AMENDMENT OF SOLICITATION/MODIFICATION OF CONTRACT				1. CONTRACT ID CODE		PAGE OF PAGES 12	
2. AMENDMENT/MODIFICATION NO. 0003		3. EFFECTIVE DATE 15 SEP 99		4. REQUISITION/PURCHASE REQ. NO.		5. PROJECT NO. (If applicable)

14. DESCRIPTION OF AMENDMENT/MODIFICATION (Organized by UCF section headings, including solicitation/contract subject matter where feasible.) The Solicitation for UPGRADE BUILDING 3202, FORT HOOD, TEXAS, is amended as follows:							
See Continuation Sheet.							
NOTE: The Bid Opening date remains"20 September 1999, 2 p.m. local time," as previously announced.							
Except as provided herein, all terms and conditions of the document referenced in Item 9A or 10A, as heretofore changed, remains unchanged and in full force and effect.							
15A. NAME AND TITLE OF SIGNER (Type or print)				16A. NAME AND TITLE OF CONTRACTING OFFICER (Type or print)			
15B. CONTRACTOR/OFFEROR		15C. DATE SIGNED		16B. UNITED STATES OF AMERICA		16C. DATE SIGNED	
(Signature of person authorized to sign)				BY (Signature of Contracting Officer)			
NSN 7540-01-152-8070 PREVIOUS EDITION UNUSABLE				30-105-02		STANDARD FORM 30 (REV. 10-83) Prescribed by GSA FAR (48 CFR) 53.243

FORT HOOD
K

1 SECTION THRU SLAB FOR CHILLDER & BOILER

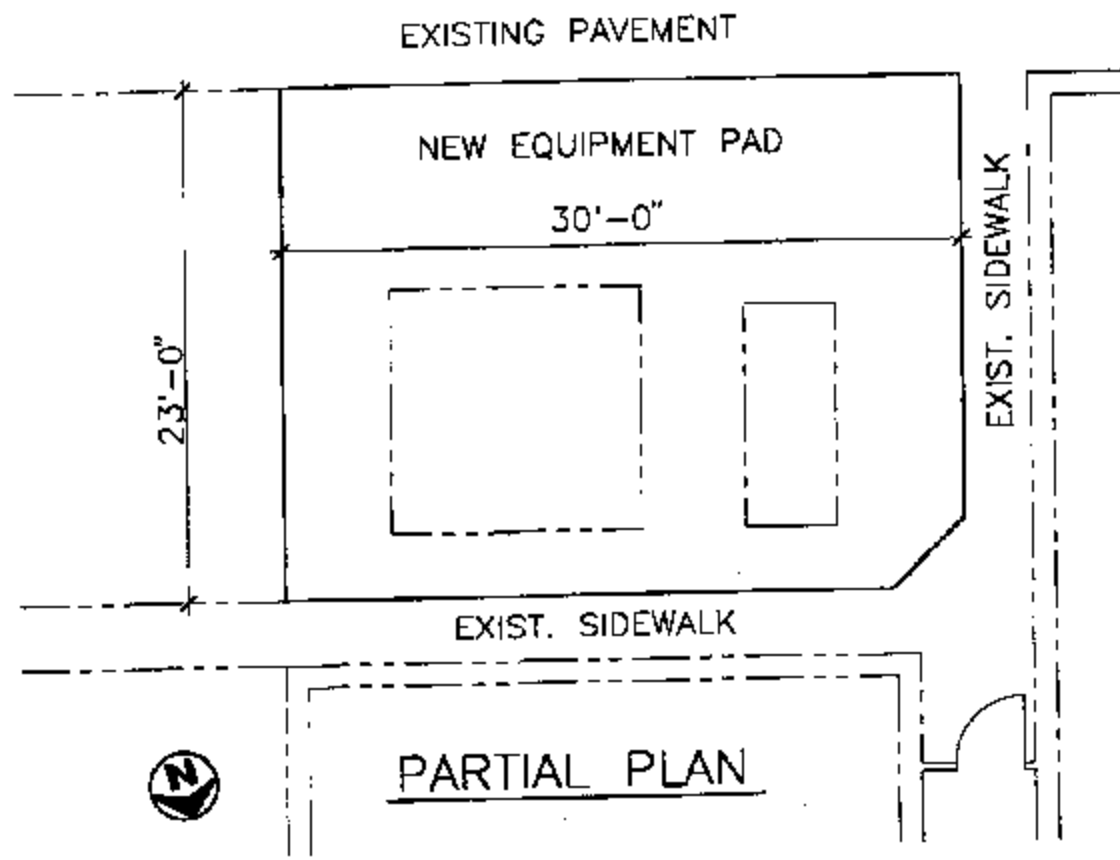
1. Drawing Sheet A5 - Detail 7, Pilaster Detail. Change note to read:
"Trim Numbers supplied by Lone Star Plywood & Door Corp., Coppell, TX, (214) 304-1234 or (214) 471-1116."
2. Drawing Sheet A10 - Detail 1, Exterior Wall Section. Change the item which reads "Industrial Louvers Model 650XPSS and Accessories or Equal Alternate 1" to read "Industrial Louvers Model 650XPSS and Accessories or Equal."
3. Drawing Sheet H2 (originally M2), HVAC Plan. Add the attached detail "Section thru Slab for Chiller & Boiler"
4. Drawing Sheet P1, Plumbing Demolition Plan. Change Demolition Note 7 to read "The owner will remove the existing air compressor. The Contractor shall remove all associated piping, fittings and supports no longer required -- cap lines to remain."
